Request for Proposal (RFP)

Addendum No. 1

Project Name: N12(13-2)1,2&4 Road Improvement Project from Agency Line to Wheatfields Lake, AZ

Owner: Navajo Division of Transportation

REVISEMENTS	NO.	DATE	REMARKS	BY
	1	03/25	RVSD CALLOUT TO SHOW 2 LIFTS	JEB
DESIGN		JEB	WCEA NO. 1710009012	2025
DRAWN		ERG	PROJECT NO.	SHEET NO.
CHECK		ASF	N12(13--2) 1,2,&4	4 OF 120

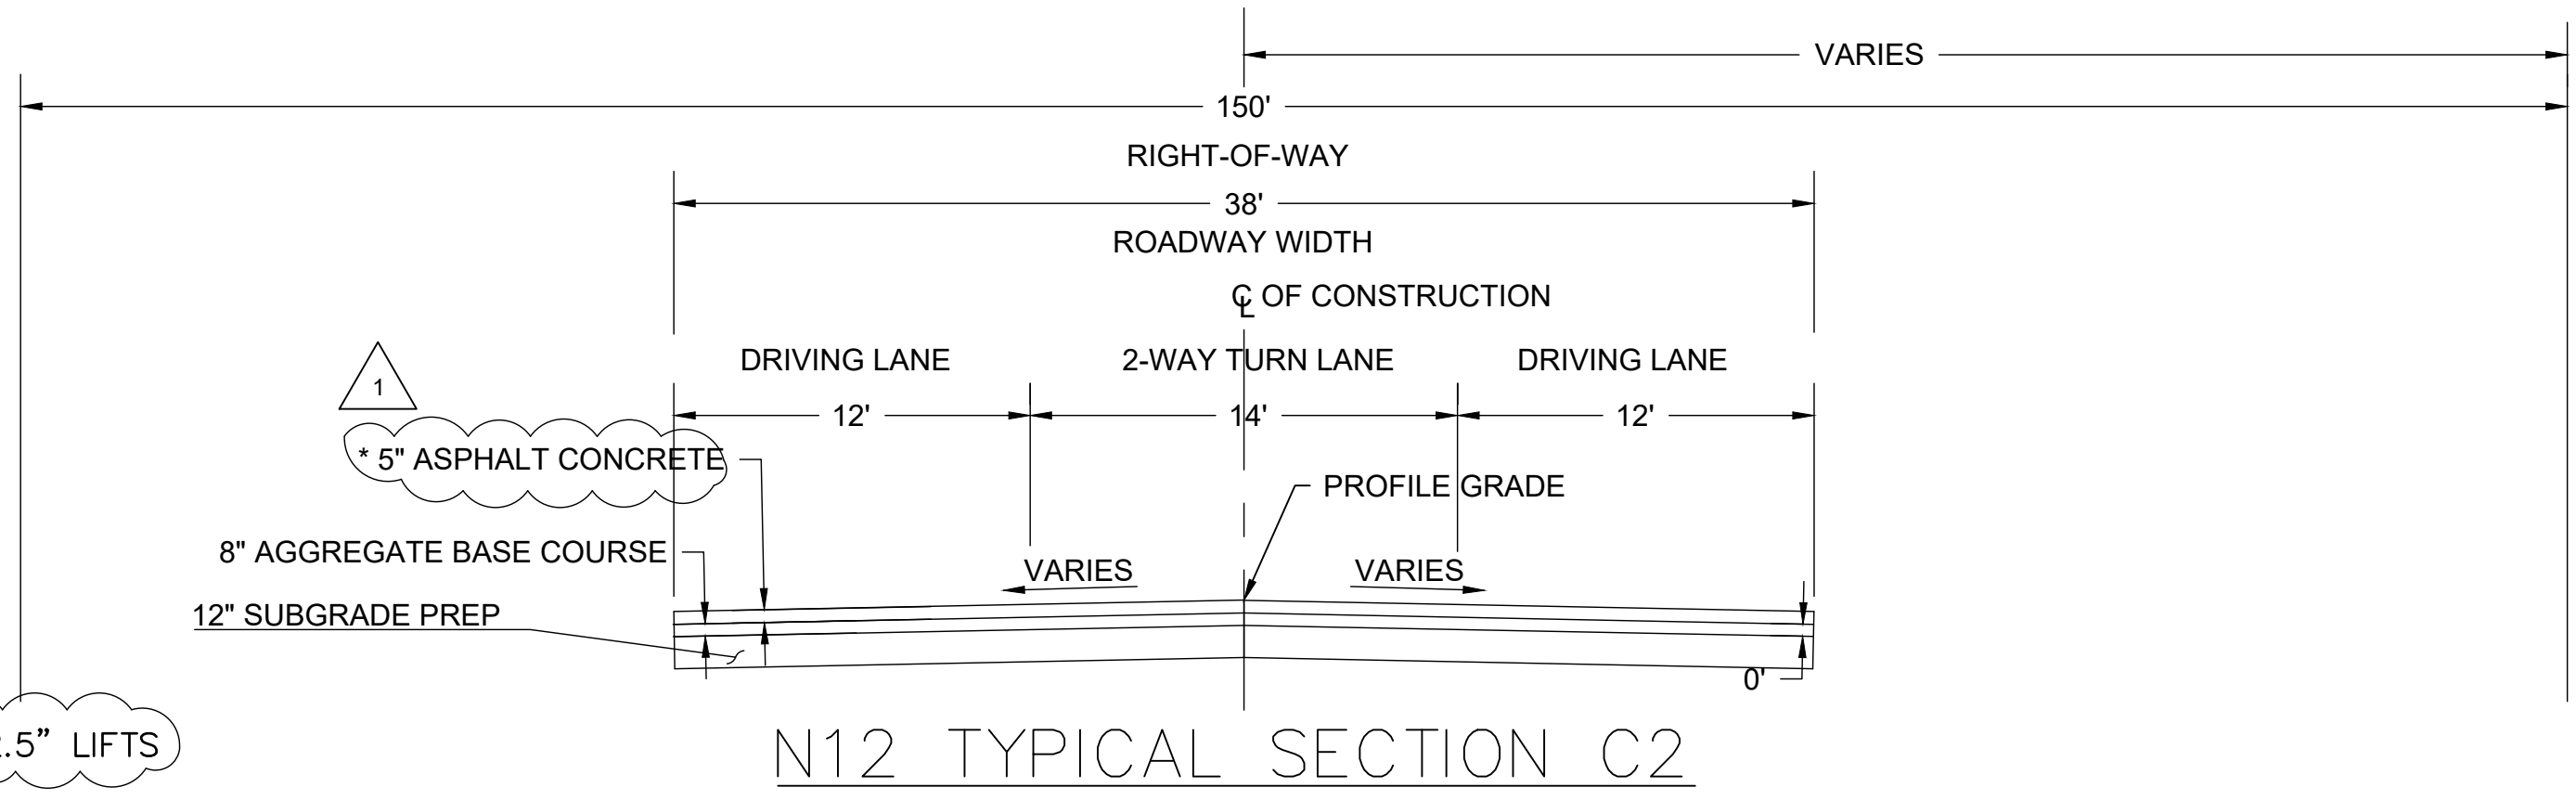
2. Plans:
 - Sheet 4: TYPICAL SECTIONS have been updated to reflect 2-2.5" asphalt lifts. Replace plan sheet and refer to the question-and-answer section.

PLAN AND PROFILE

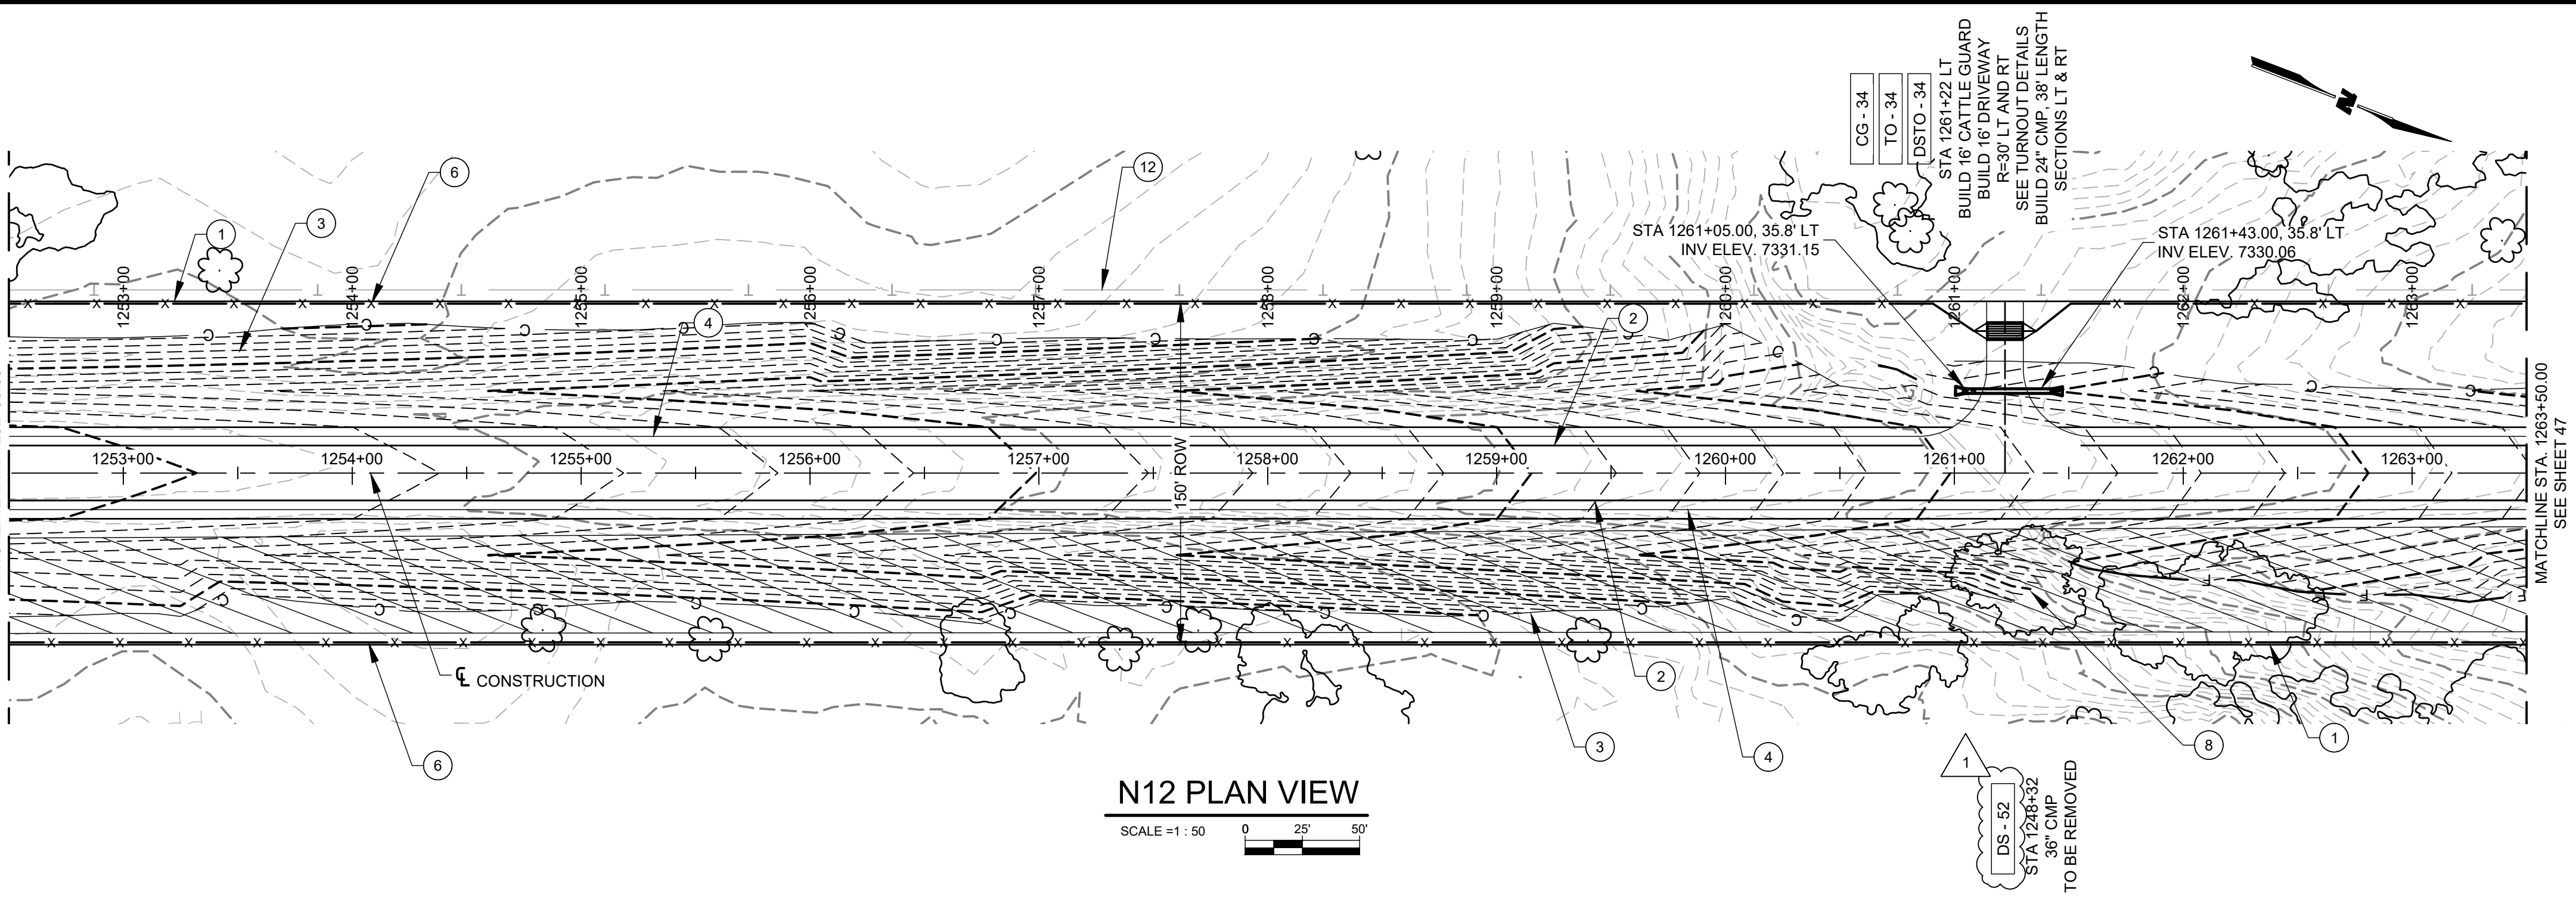
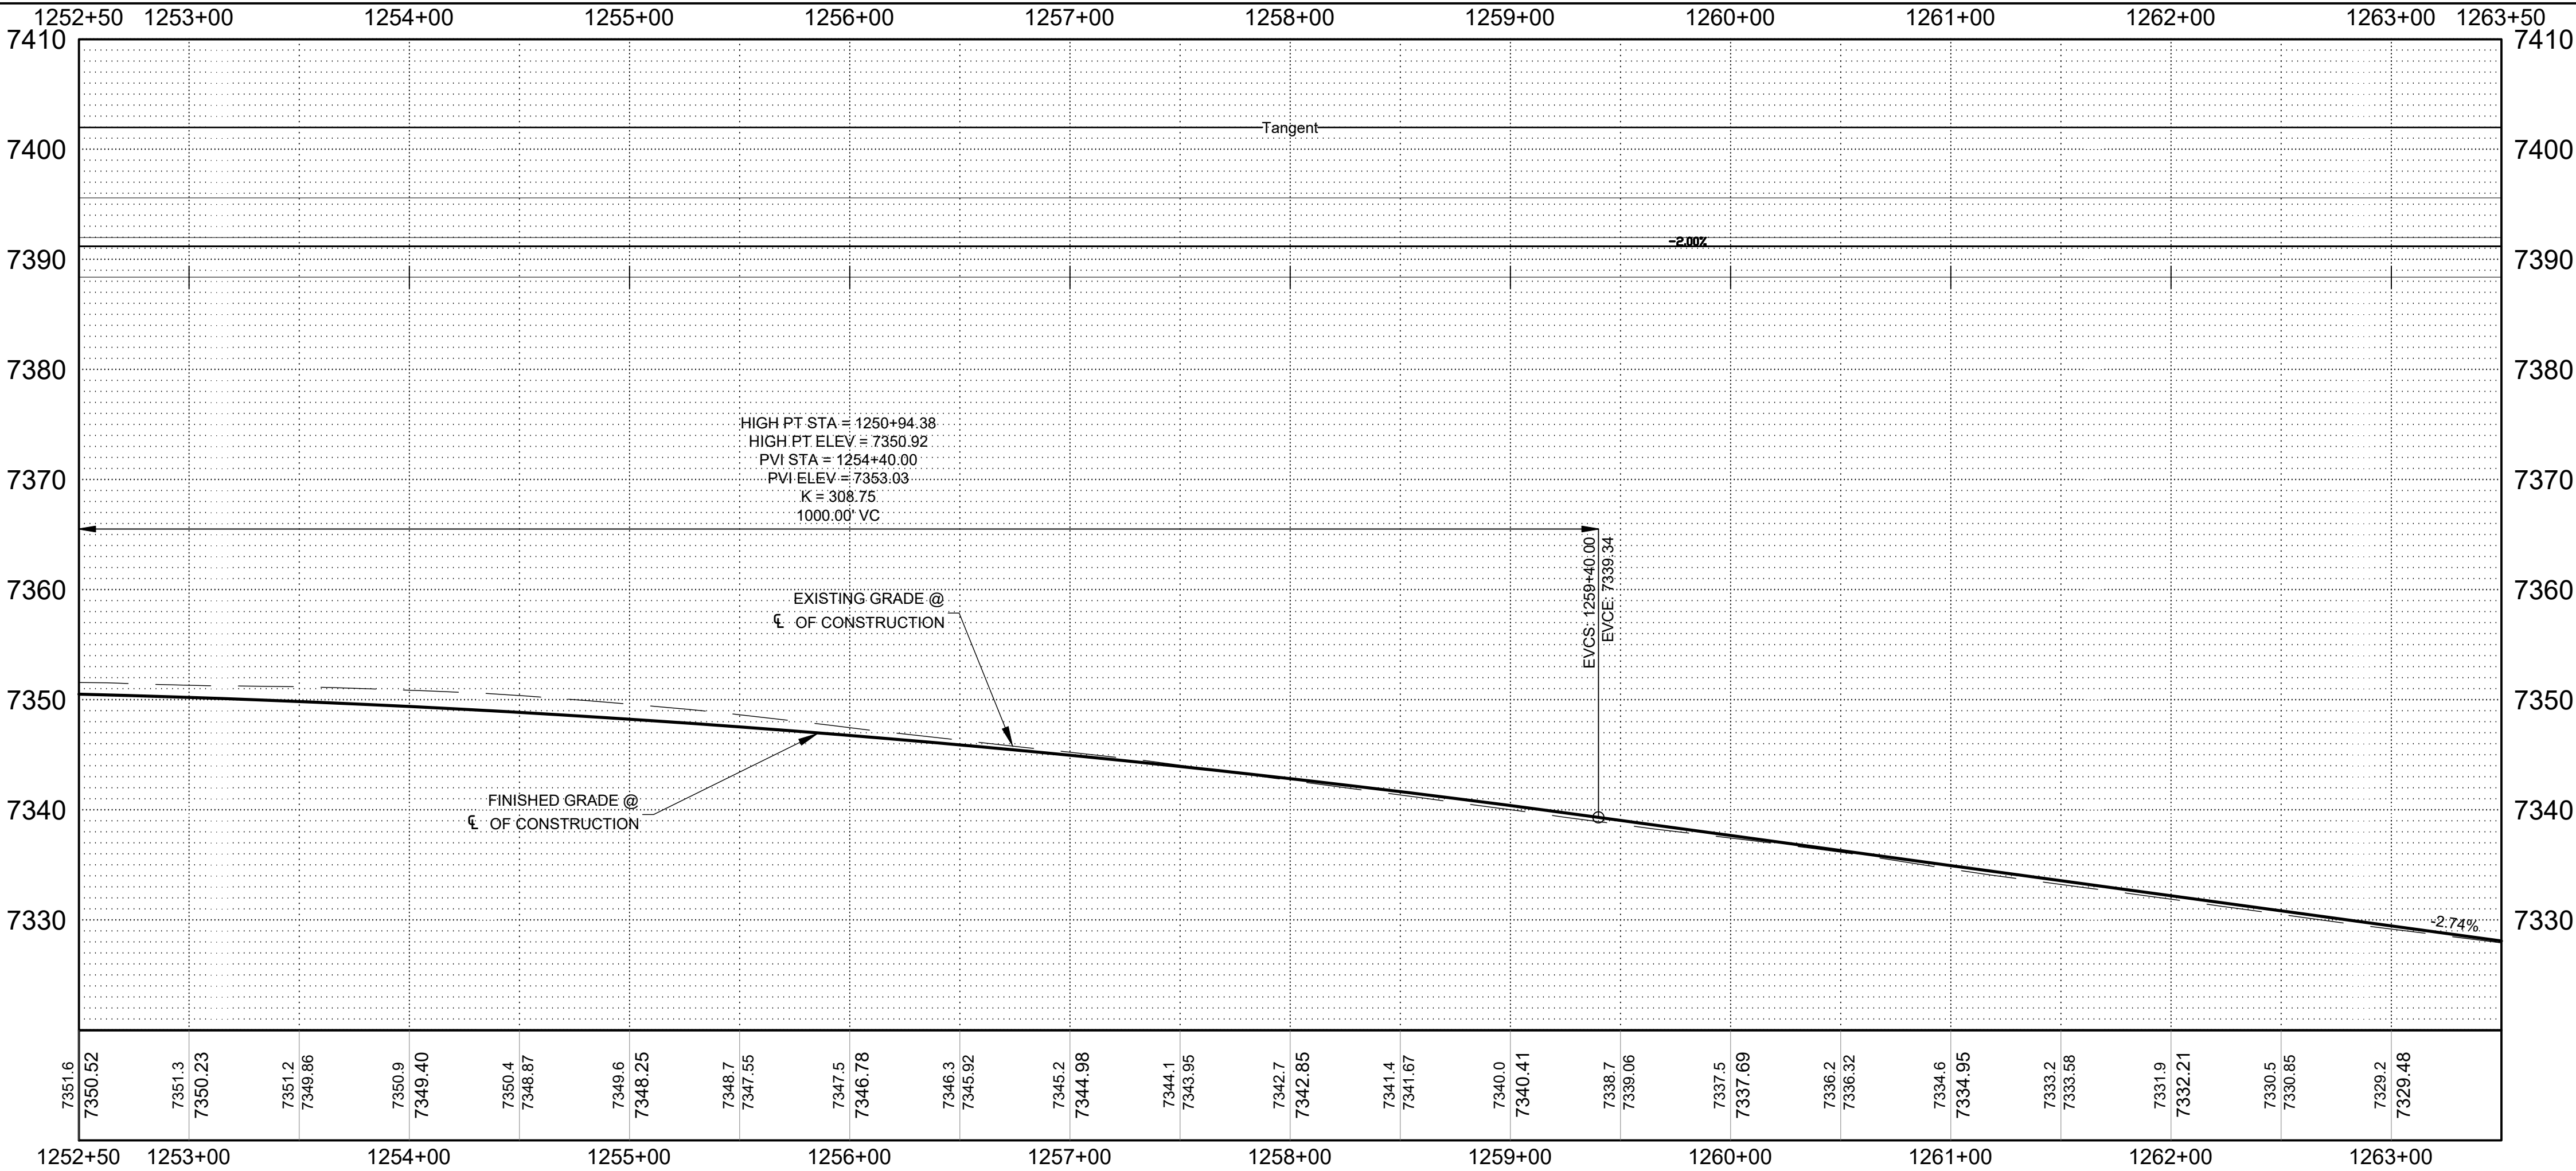
- Sheet 44: PNP-32: has been updated to reflect the removal of the existing 24" CMP. Replace plan sheet and refer to the question-and-answer section.
- Sheet 46: PNP-34: has been updated to reflect the update of pipe callout DS-52. This existing 36" CMP is to be removed. Replace plan sheet and refer to the question-and-answer section.
